**RE: Managed fill, 363 Jones Road, Dury
Response to Section 92 Questions**

Styles Group assessed the potential noise effects of the proposed managed fill at 363 Jones Road, Dury and provided an acoustic report dated 1 November 2024.

This letter provides further noise mitigation advice and a response to the Auckland Council s92 request dated 4 March 2025. The matters relevant to noise and vibration are set out below:

Figure 1: Location of the northern bund (level 1)

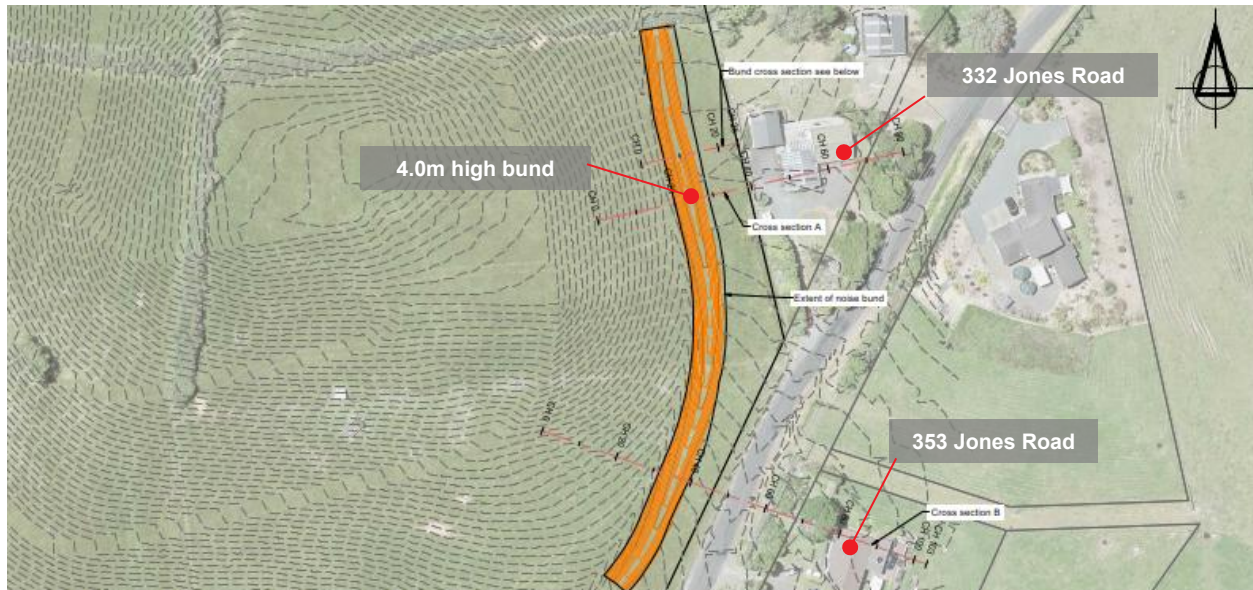
3d. Please confirm the level of mitigation (in decibels) provided by the proposed noise bund, as the acoustic assessment states the bund will be located approximately 20-25m from the eastern boundary but the plans show the bund will be much closer.

The proposed northern bund (levels 1) height has increased from 3.0m to 4.0m since we provided our initial assessment. The increased bund height will provide additional and more effective noise attenuation.

Figure 1 overleaf shows the location of the northern bund (level 1).

Figure 3: South-west level 1 bund (3.0m height) at 185m RL

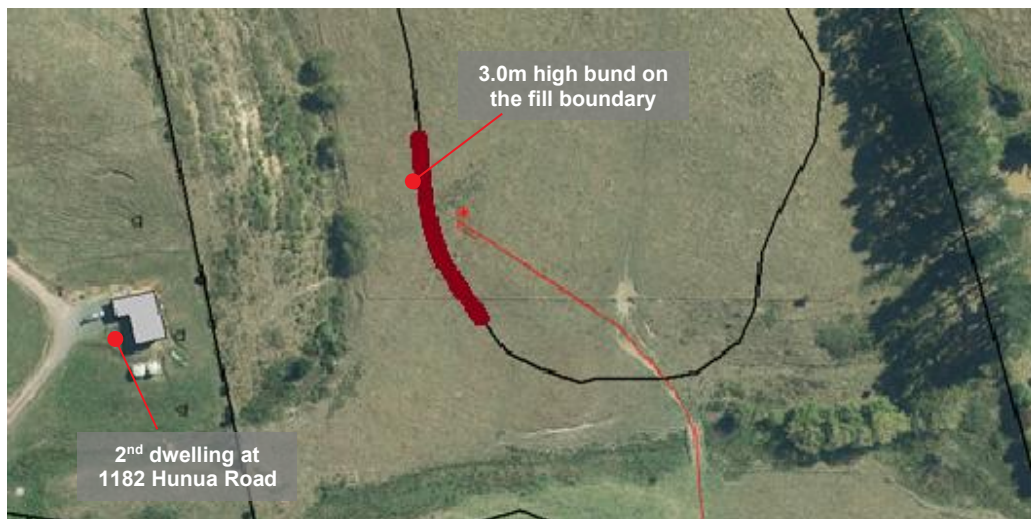
3e. Please update the noise assessment to consider potential effects on the newest dwelling located at 1821 Hunua Road (which was not shown on the previous aerial images).

The first high bund (level 1) will 50m long and 3.0m high. The bund will be constructed on the south-west fill boundary, as shown below in Figure 3:

The highest predicted noise rating level with the multi-level bund option is 54 dB L_{Aeq} at the notional boundary of 1821 Hunua Road. The predicted noise rating level complies with the 55 dB L_{Aeq} noise limit in AUP Standard E25.6.3 by a margin of 1 dB.

Figure 8: Level 1 bund (4.0m height) at RL 221 RL

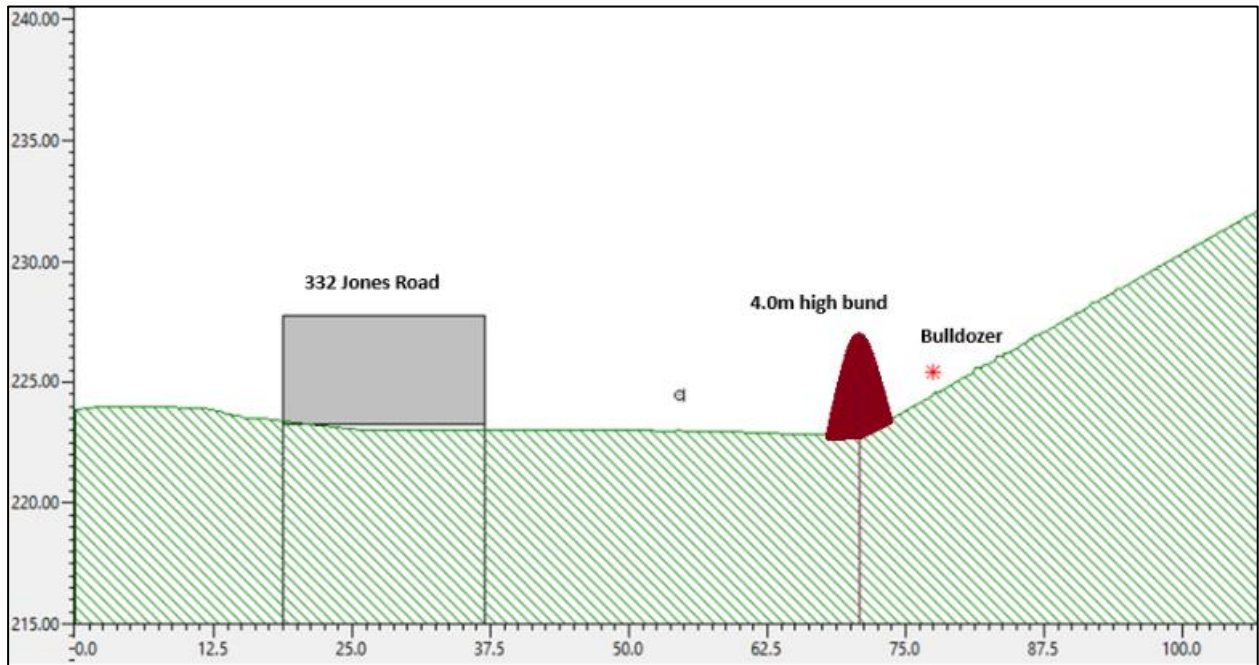
3f. If you have considered any amendments to the proposal as a result of your review of the submissions, or have any further information prepared in this regard, please advise so that this can be reviewed.

The multiple bund options will involve building bunds at four levels as the works increase in height. To provide additional noise mitigation, the northern bund level 1 and 2 heights will be increased from 3.0m to 4.0m.

Figures 8 – 11 below demonstrate how the four level bund option will work at 332 Jones Road
